Subject: LaSalle County Station
Units 1 and 2 Resolution
of Reactor Systems Branch
Questions
NRC Docket Nos. 50-373/374
LOD 81-40-19

The purpose of this letter is to provide supplemental materials requested by the NRC Staff in order to resolve issues identified by the Reactor Systems Branch (RSB). Based on meetings with that Branch on February 5 and February 11, 1981 the questions requiring further action by the applicant have been reduced to the following:

Figure 15.0-3 Minimum Operating CPR Limit

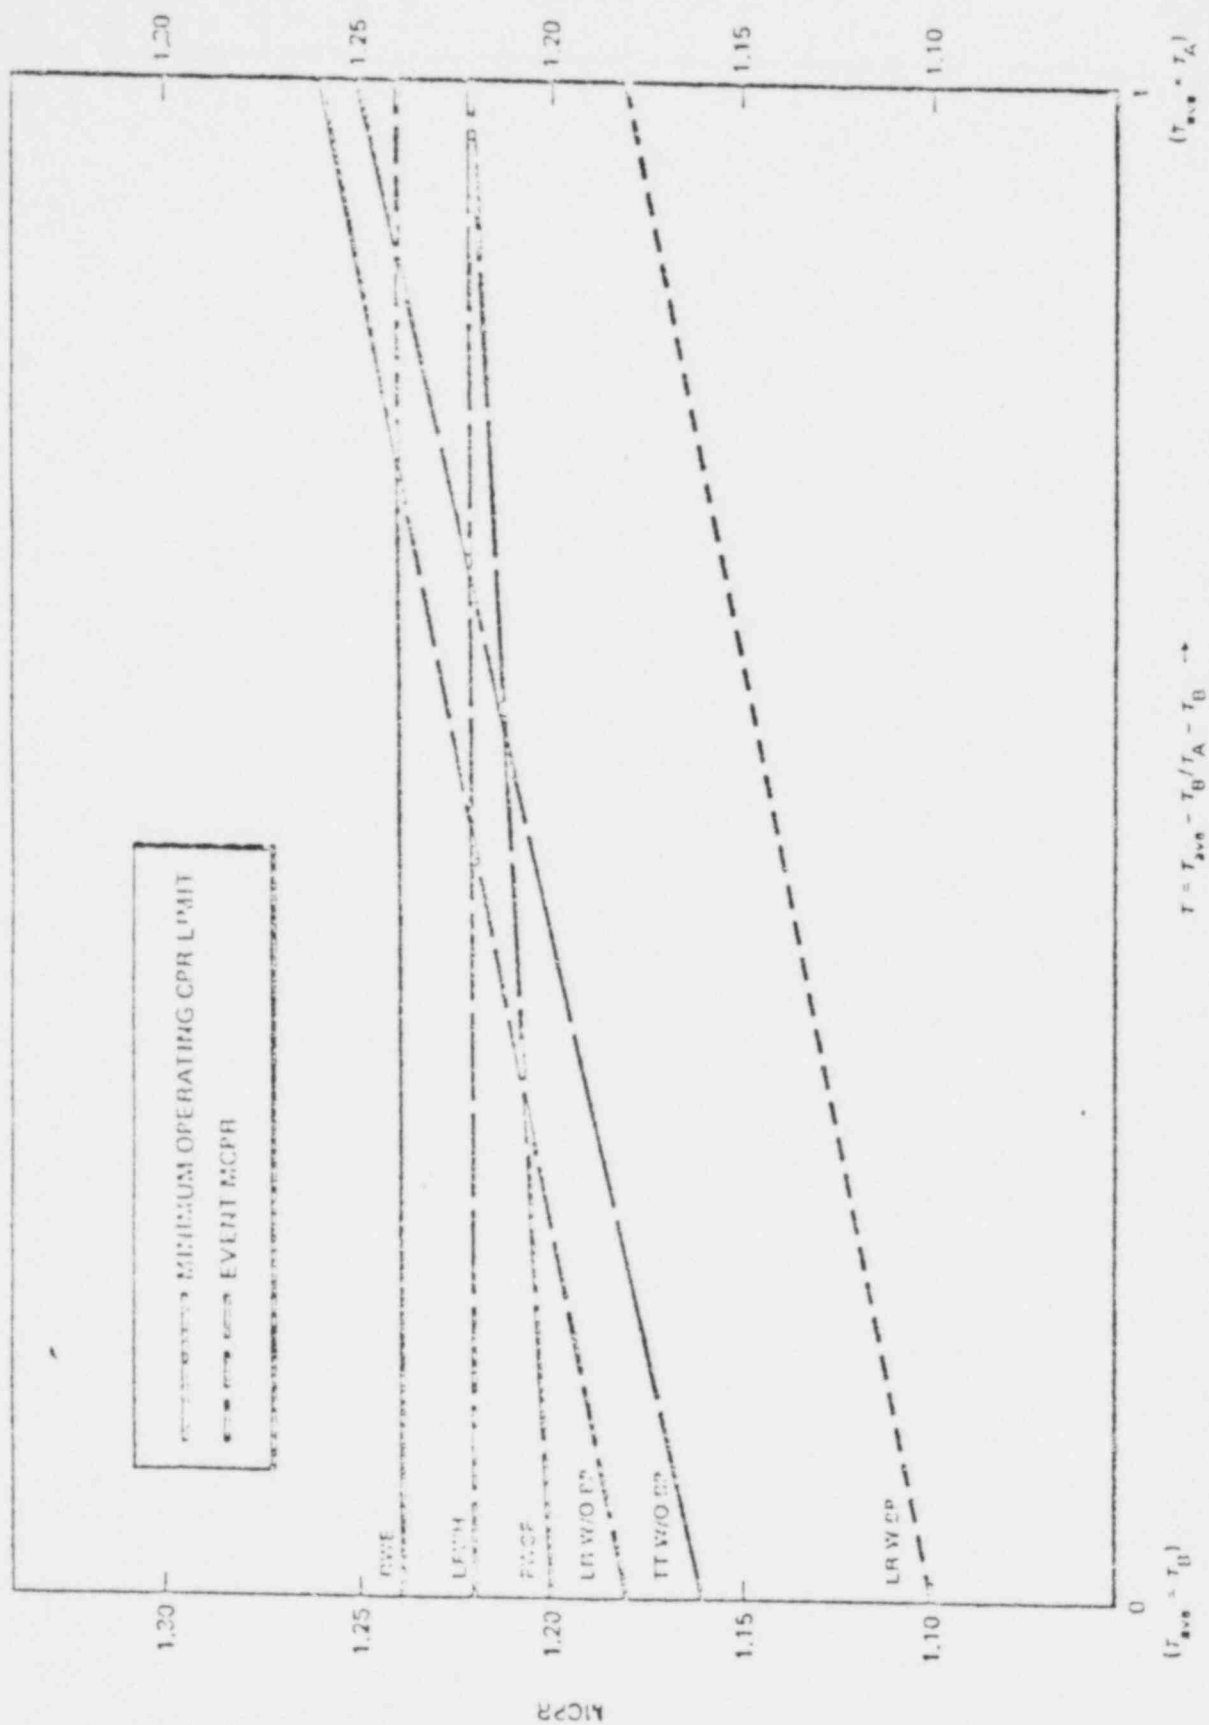
- 1) The change in the critical power ratio (CPR) which would result in the safety limit CPR (1.06) being reached, is calculated for each event. These CPR values are shown in Table 15.0-2.
- 2) The Δ CPR value for each event is then added to the Safety Limit CPR value (1.06) to yield the event-based MCPR, except for those events whose Δ CPR is calculated using ODDN.
- 3) For events whose Δ CPR is determined by ODDN (all rapid pressurization events), the event-based MCPR is determined in conjunction with NRC-additive correction factors, the Δ CPR, and the Safety Limit CPR. These correction factors are in Table 15.0-1.

These results are given in Figure 15.0-3 for limiting transients and accidents.

The operating limit MCPR is the maximum locus of values from this event MCPRs calculated with the above method. The maximum calculated MCPR is depicted by the solid line in Figure 15.0-3. Maintaining the CPR operating limit at or above this solid line assures that the LaSalle Safety Limit CPR of 1.06 is never violated.

MODIFICATIONS TO CRD & SCRAM DISCHARGE VOLUME INSTRUMENTS

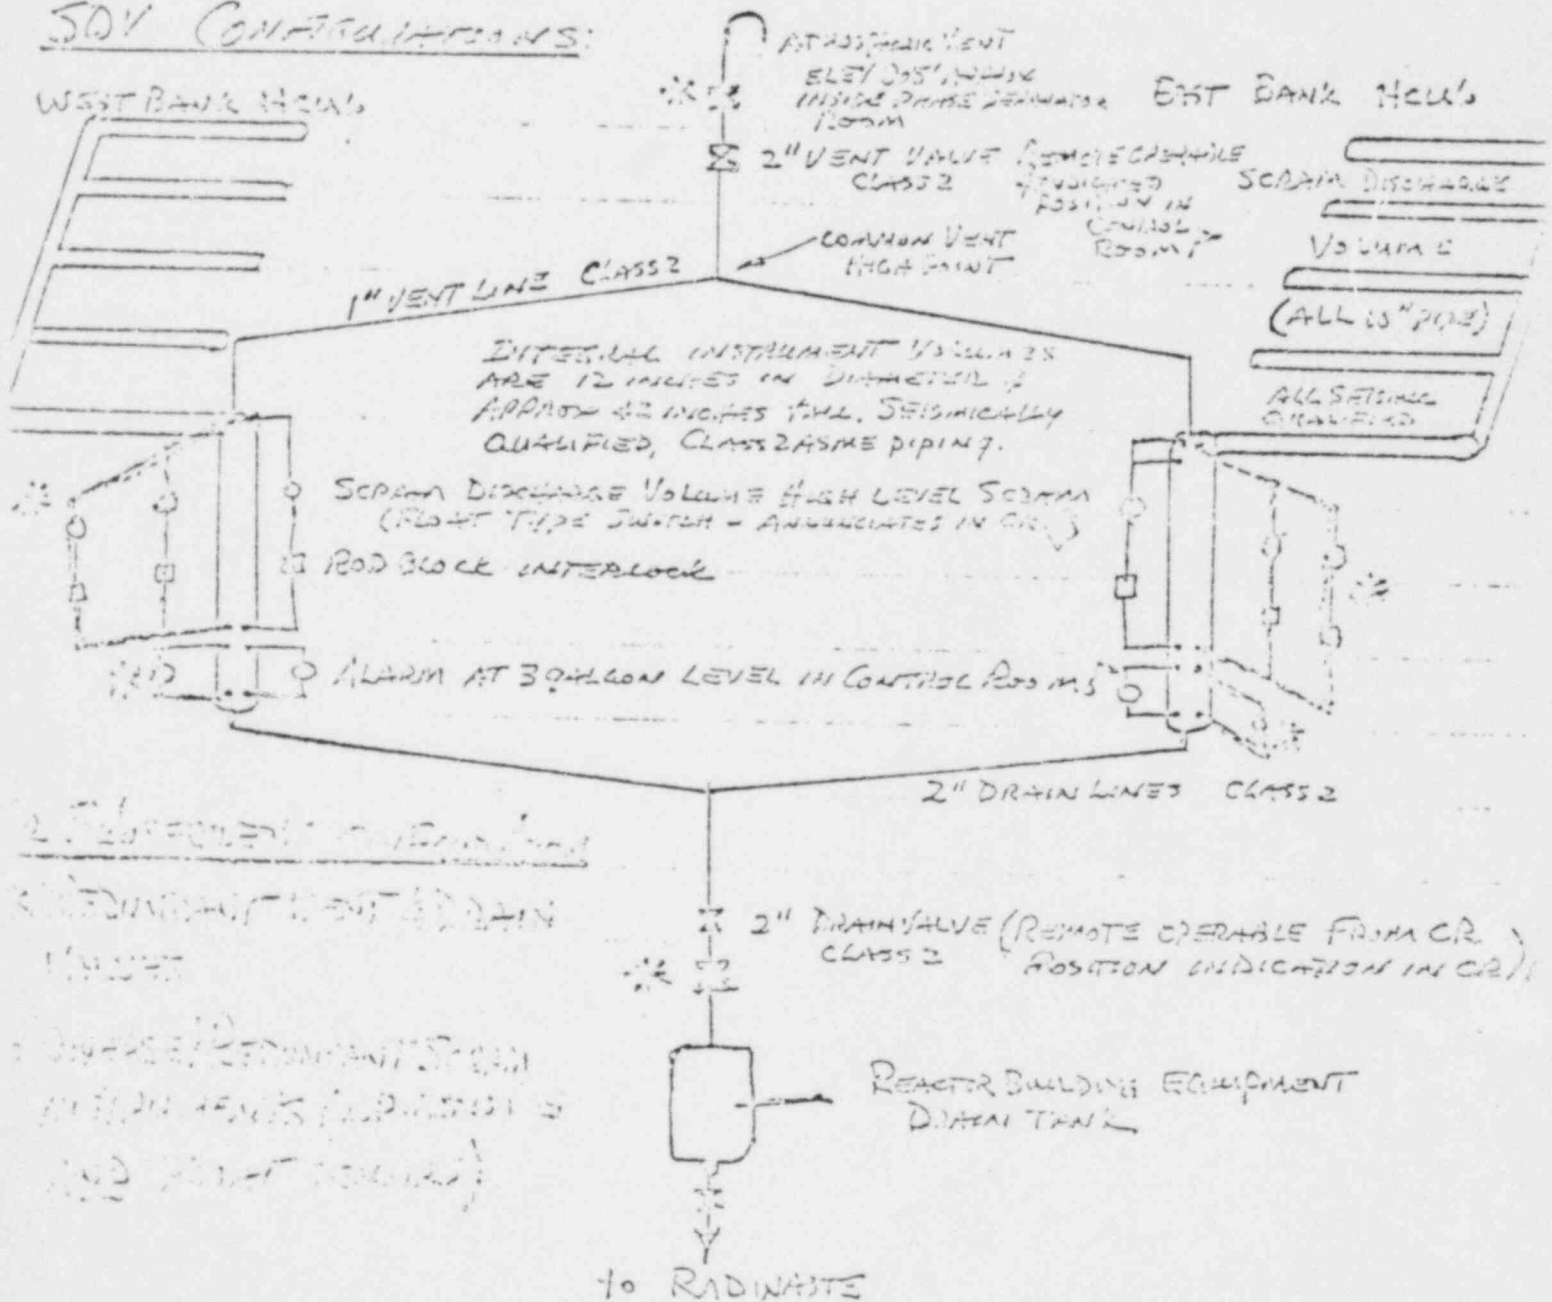
The LaSalle County Scram Discharge Volume (SDV) System has been reviewed in depth to ascertain the extent to which system modification is required to satisfy the design criteria developed by the BWR Owners Group and accepted by the NRC Staff. The LaSalle County design represents a marked improvement over that installed at Browns Ferry and is, therefore, judged by the applicant to justify the operation of LaSalle County Unit 1. The SDV system as it will exist at the time of Unit 1 fuel loading is shown in Figure E-1, and will hereafter be referred to as the "current" design.

The current design consists of two separate discharge volume headers, the piping for which is 10" dia. There exists an integral instrumented volume 12" dia at the end of these 10" headers. The instrument volume now provides redundant high level alarm and scram instrumentation. The scram instruments being of the Magnetrol design. The drain from the two instrumented volumes, which is a 2" dia pipe, is common to the two volumes, as is the single vent line. The vent line is vented to atmosphere. Both the vent and drain lines currently have a single valve to isolate the SDV.

Modifications to the system are planned for completion upon receipt of qualified equipment to provide (1) diverse level instrumentation (ΔP Transmitters) on each of the instrumented volumes, and (2) a second valve on the system vent line. The taps for the additional level instruments will be completed prior to fuel loading to facilitate the completion of the modification later.

THE PRE-FUEL LOAD CONFIGURATION PROVIDES SAFETY EQUIPMENT REDUNDANCY FOR THE SCRAM DISCHARGE VOLUME HIGH LEVEL SCRAM. IT ALSO PROVIDES SEPARATION OF THE VENT AND DRAIN PIPING TO OVERCOME THE BROWN'S FERRY DEFICIENCY. THE BASIC DESIGN OF LITSHILL PROVIDED COMPLIANT FEATURES AS FOLLOWS AS RECOMMENDED BY THE OWNERS GROUP CRITERIA:

A DIAGRAMMATIC REPRESENTATION OF THE LITSHILL CRD SYSTEM IS ATTACHED TO SHOW THE PRE-FUEL LOAD CONFIGURATION AND THE SUBSEQUENT CONFIGURATION WHICH ADDS THE FOLLOWING CHARACTERISTICS:

1. DIVERSE INSTRUMENT VOLUME SENSORS, WHEREAS THE PRE-FUEL LOAD CONFIGURATION HAD REDUNDANT FLOAT-TYPE LEVEL SWITCHES, THE SUBSEQUENT CONFIGURATION HAS FLOAT-TYPE AND

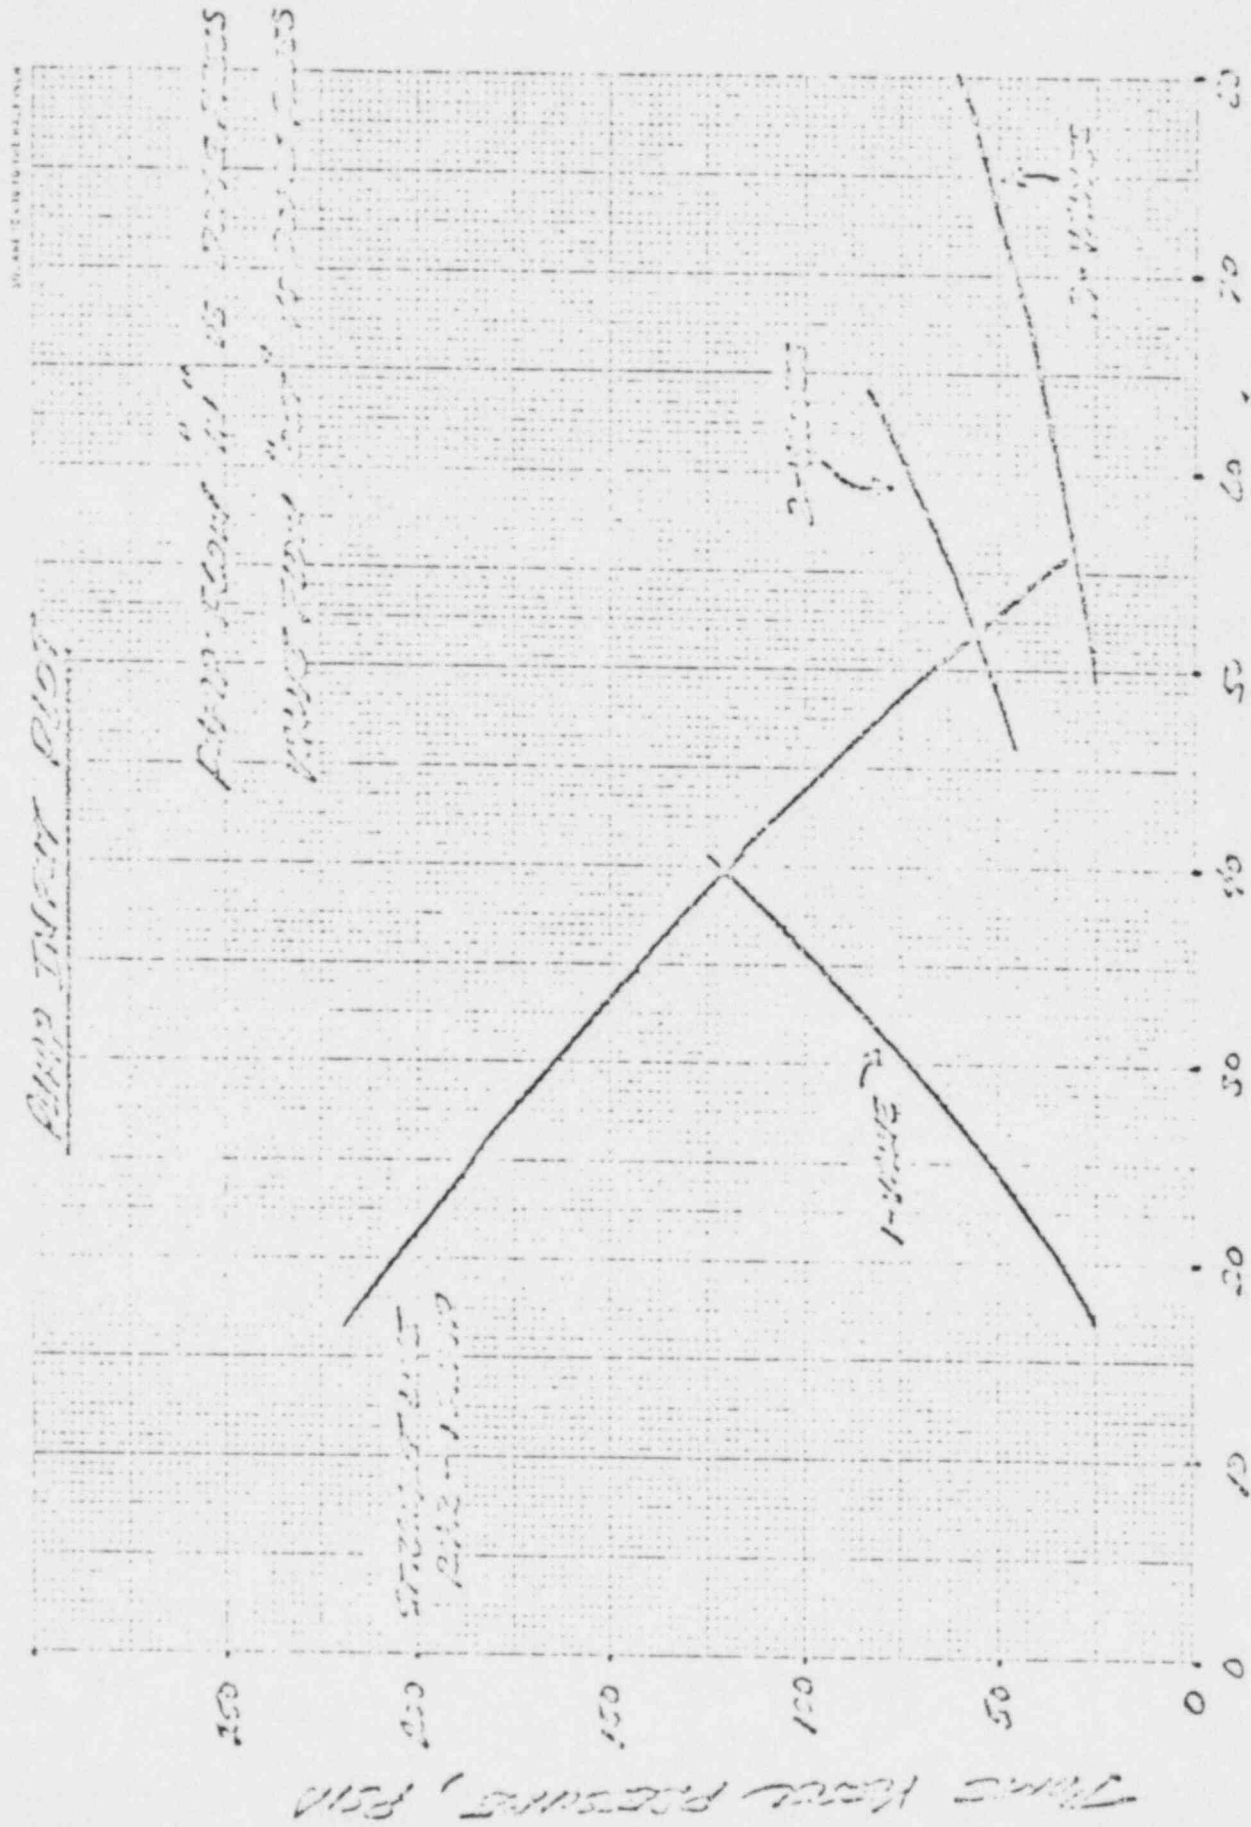
Crossplot this on pump input plot. *SEE ATTACHED PUMP INPUT PLOT*

1 Value	2 Value	3 value
Dome pressure psia	122	58	31
Valve flow, #/min	39500	52000	56000
Pump flow in gpm	4795	6313	6793
